From: Perry HE (HTX) <Perry_HE@spf.gov.sg>
Sent: Wednesday, 4 December 2019 2:35 PM
To: 'assignments'
Cc: Kim Pang CHAY (HTX); Kwee Huat TAN (HTX); 'Denise Tay (LKKAuto)'
Subject: Appraisal Services for SPF vehicle at INDECO - GBF3172L

CONTRACTOR :	Indeco Engineers Pte Ltd	VEH TYPE :		UNIT :	PROCOM	Reference No.
VEH NO :	GBF 3172 L	MB	REPAIR TYPE:	ACCIDENT		MHA/SPF/2019/12-0002 1100037962
VEH MAKE/MODEL	HYUNDAI HI		Mileage:	92129

ACCIDENT/DAMAGE REPAIR AND AD HOC WORKS REQUEST FORM

AUTOMOTIVE ENGINEERING & MGT DIVISION Ref : CS/SPF19021458/Ggf3e2

Pls mark affected area with X

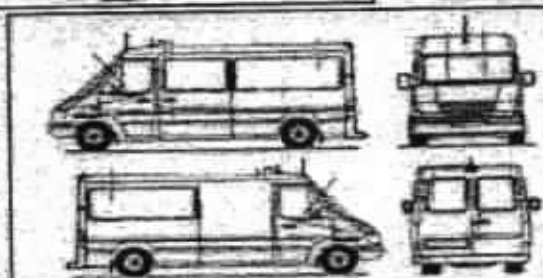
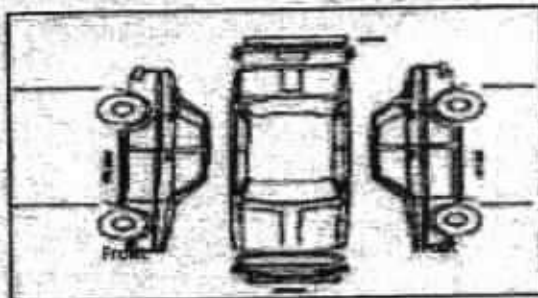
FRONT BUMPER DISLOGED

DRIVER DOOR DENTED AND GRAZED

HEADLIGHT CRACKED

FRONT RIGHT RIM DENTED

RIGHT FRONT FENDER DAMAGED

FRONT HOOD DENTED
